**PARTS & SERVICE
NEWS**

REF NO.	AT01234
DATE	Jan. 9, 2002

SUBJECT: INTRODUCTION OF IMPROVED DOWEL PIN ON S(A, AA)6D140 ENGINE FOR SEPARATE MARKETING

PURPOSE: To introduce improved dowel pin effective to prevent occurrence of cracks in the cylinder block of the independently marketed S(A, AA)6D140 series engines

<Details of the change of the dowel pin>

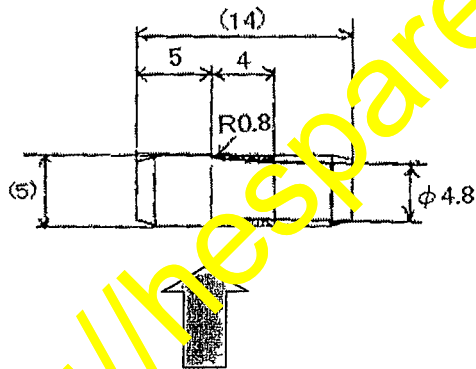
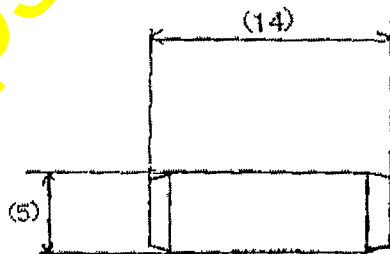
The shape of the dowel pins being used for installation of the #7 main cap has been changed to alleviate the stress being occurred in the cylinder block.

● Shape of the pin after the change

● Shape of the pin before the change

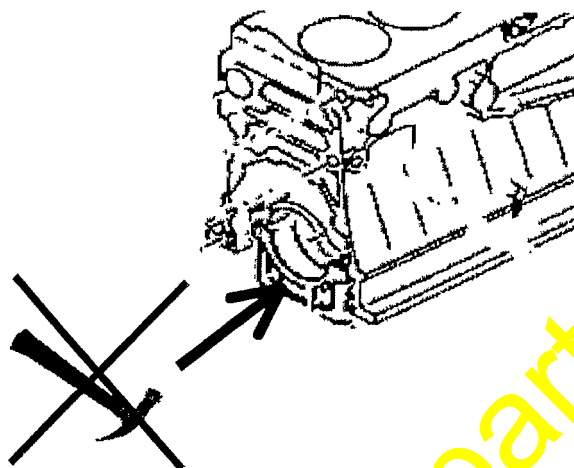
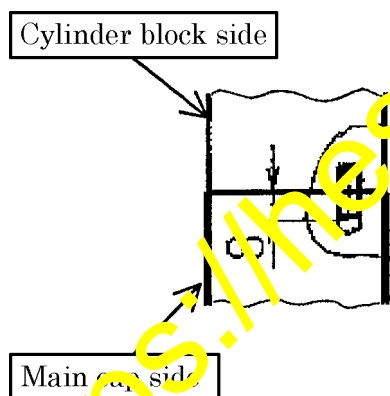
<Note> Since the pins are being inserted as shown in this Service News, do not try to hammer the main cap forcibly in the longitudinal direction when removing and reinstalling the cap.

(If it is hammered forcibly in the longitudinal direction, the main cap or the cylinder block may be damaged.)

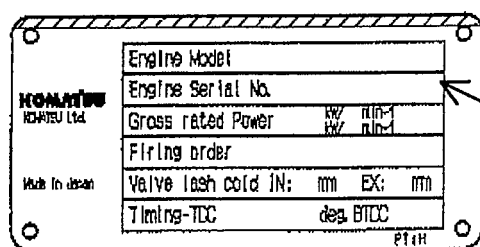
- (2) Adjust the projection of the new dowel pins from the cylinder block relevant to this modification to the following distance (8 mm).
